**ADDENDUM NO. 4 TO PROJECT NO. 47175**

**CONSTRUCTION, ELEVATOR, HVAC, PLUMBING AND ELECTRICAL WORK  
REPLACE ELEVATORS 1 – 5  
DULLES STATE OFFICE BUILDING  
317 WASHINGTON ST  
WATERTOWN, NY**

August 10, 2023

# 1 Car Interior - Elevators 1-4

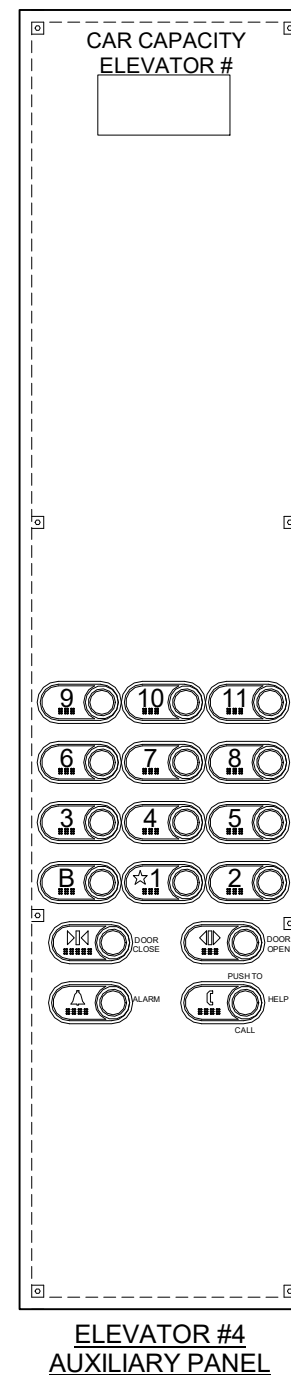
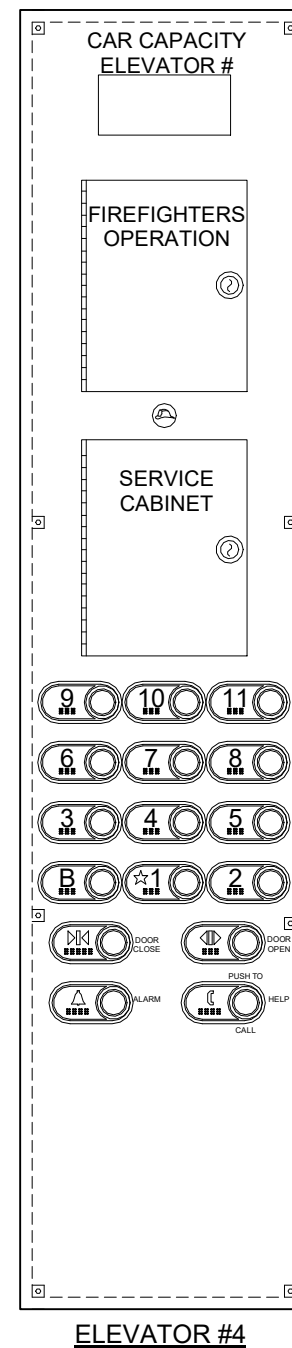
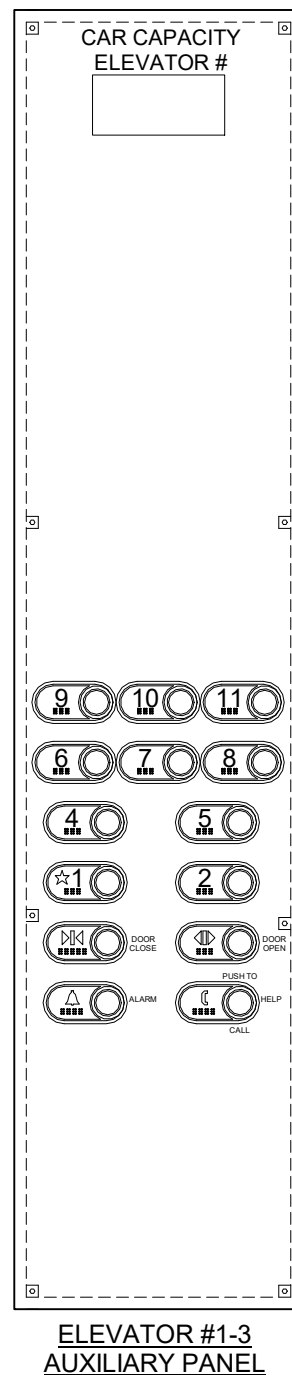
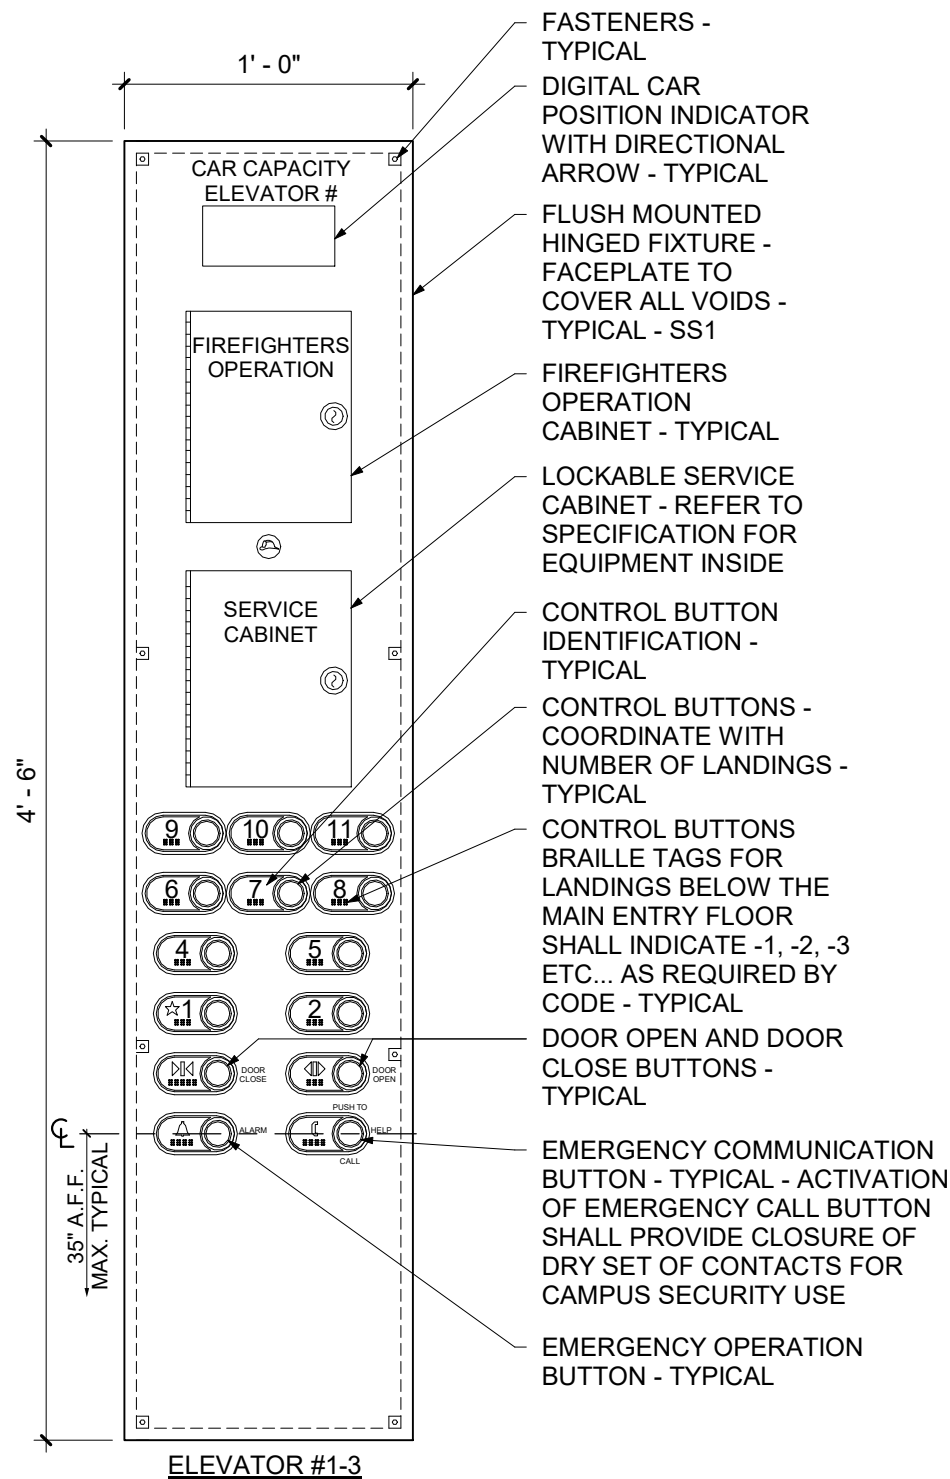
6. Drawing No. U-502:
  - a. DETAIL 1: Replace Detail 1 with 1/SK-01, attached.
  - b. DETAIL 2: Replace Detail 2 with 2/SK-02, attached.

DRAWING NUMBER:  
P-402

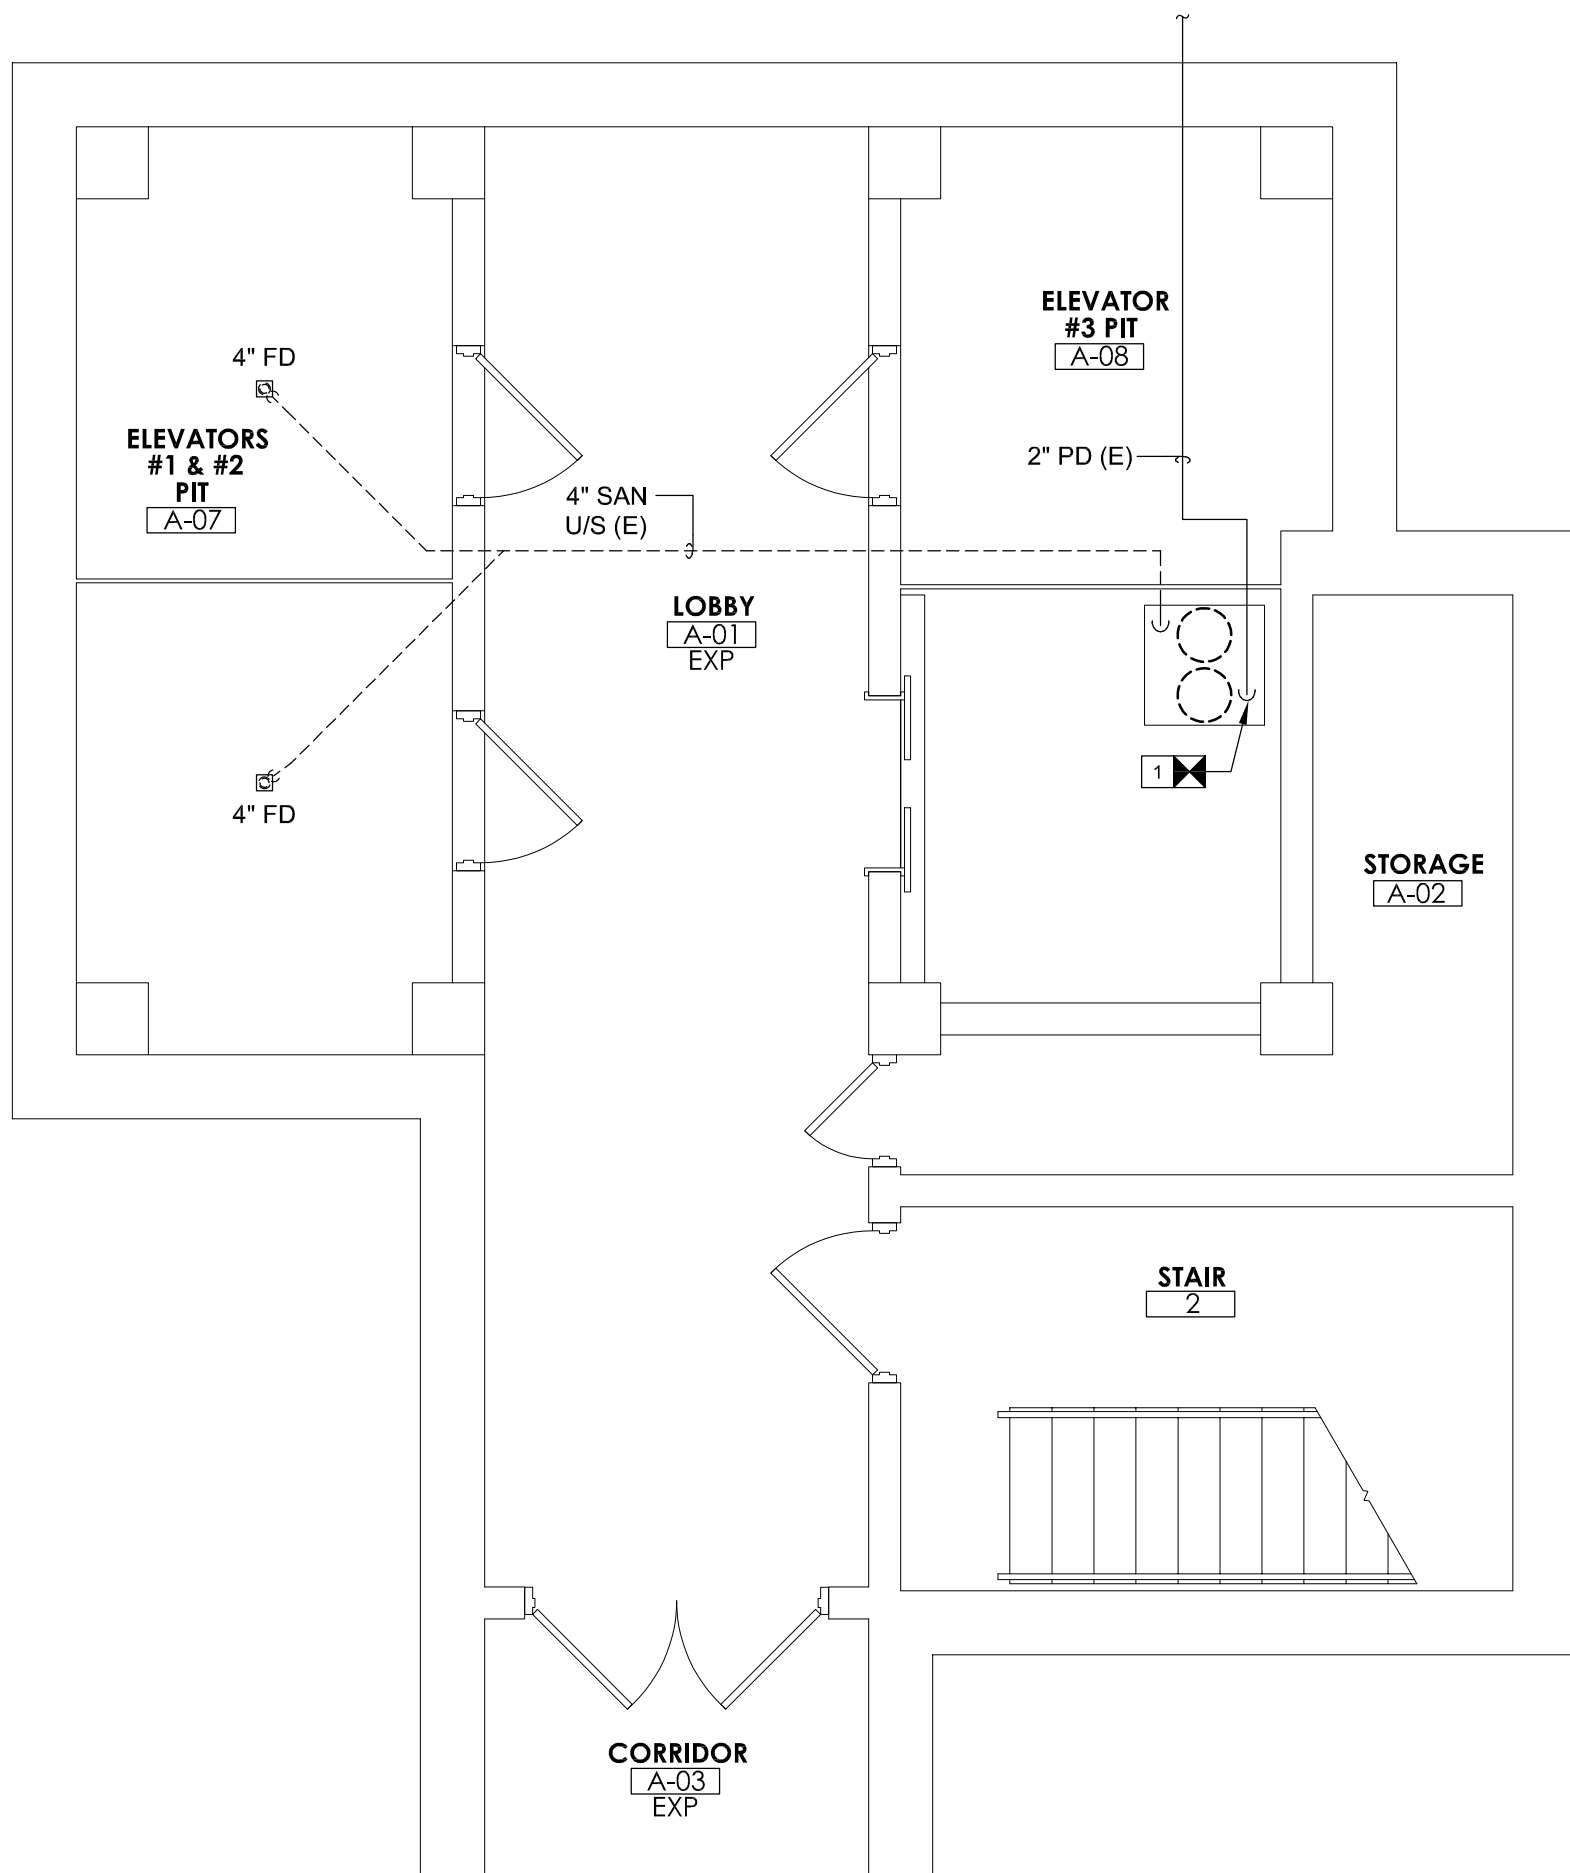
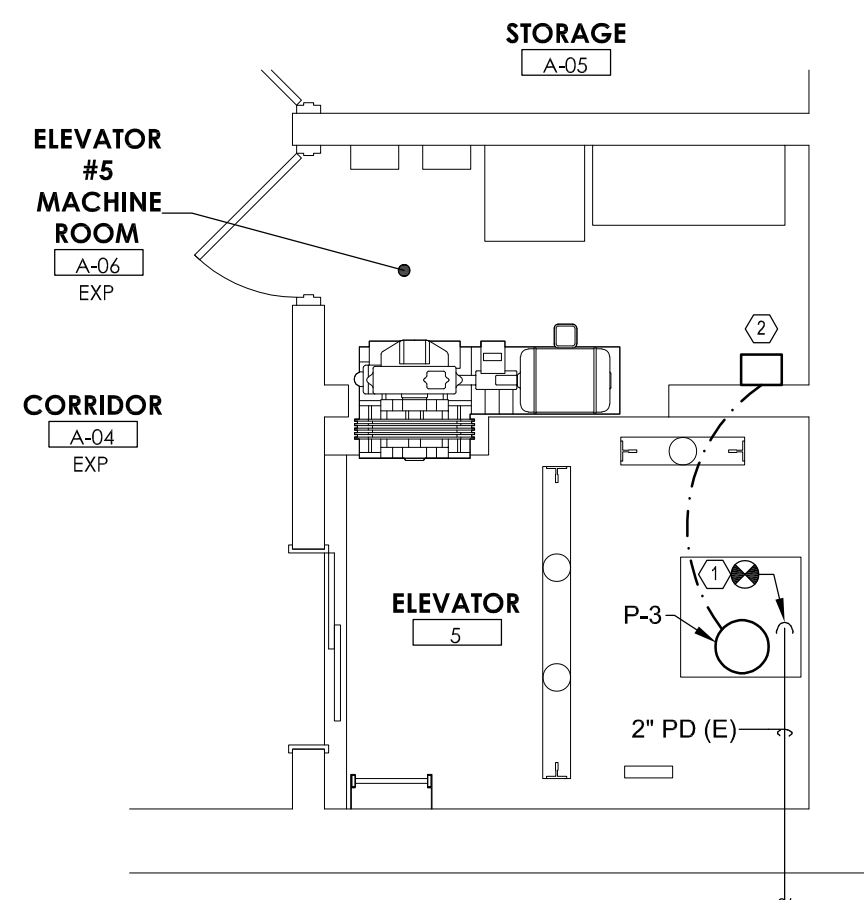
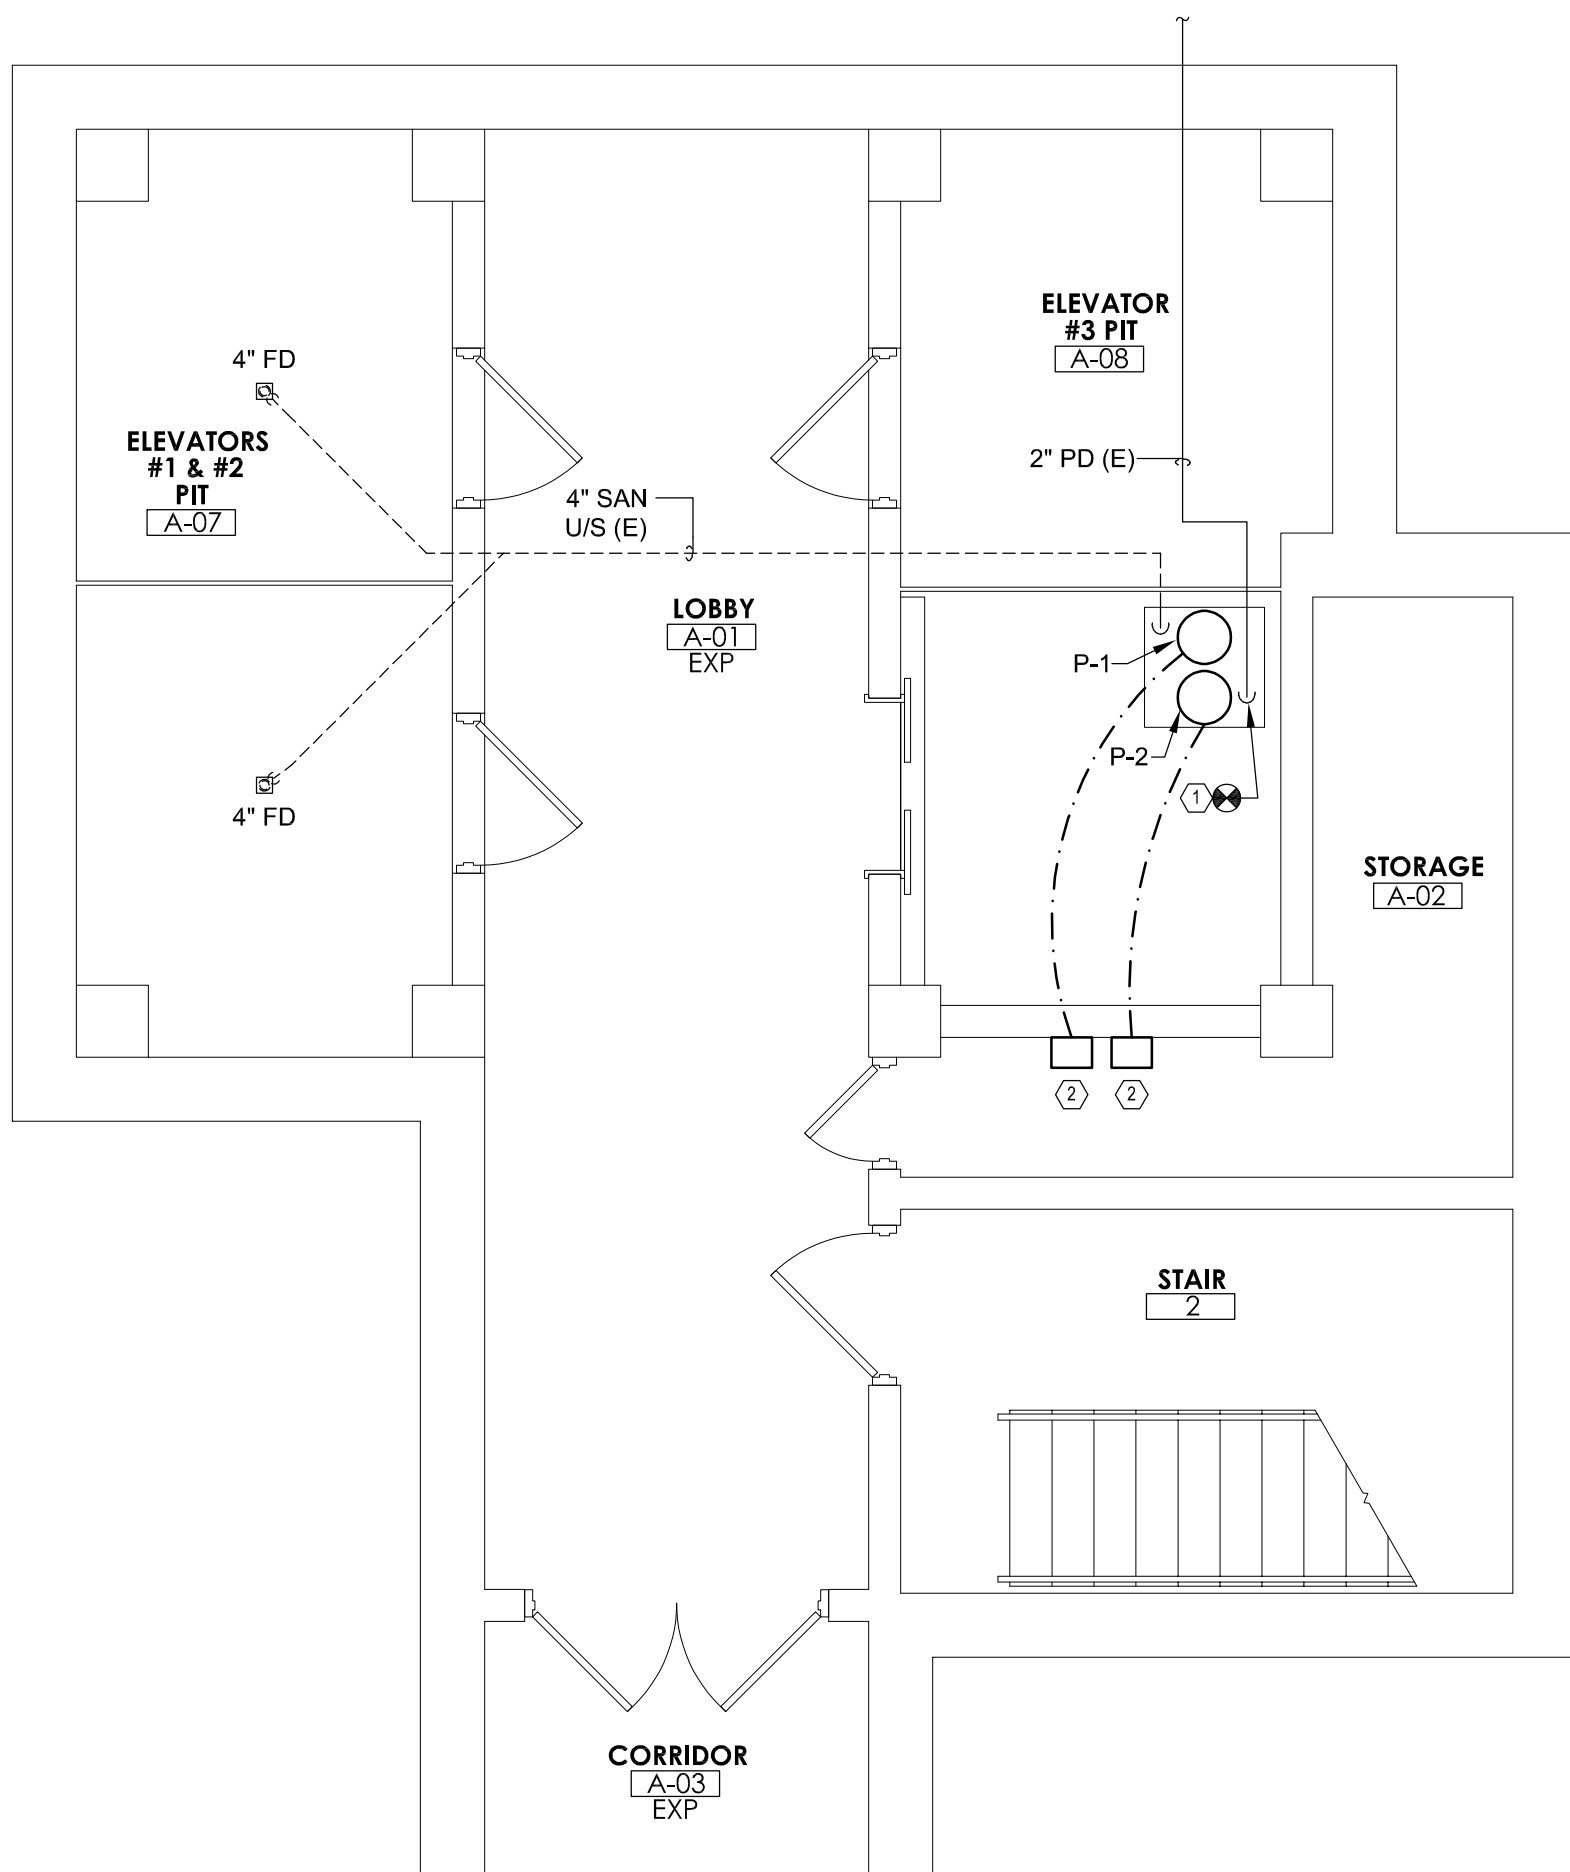
7. Revised Drawing:
  - a. Drawing No. P-402, noted “REVISED DRAWING 8/10/2023” accompanies this Addendum and supersedes the same numbered originally issued drawing.

- 1 DISCONNECT 2" PD PIPING FROM SUMP PUMPS AT LOCATIONS INDICATED. REMOVE SUMP PUMPS AND ASSOCIATED ACCESSORIES.

- 1 CONNECT SUMP PUMP DISCHARGE PIPING TO EXISTING 2" PD PIPING LEFT FROM REMOVALS.
- 2 SIMPLEX SUMP PUMP CONTROL PANEL. COORDINATE LOCATION OF CONTROL PANEL WITH EXISTING SPACE. FIRESTOP WALL PENETRATIONS TO MAINTAIN EXISTING FIRE RATINGS.
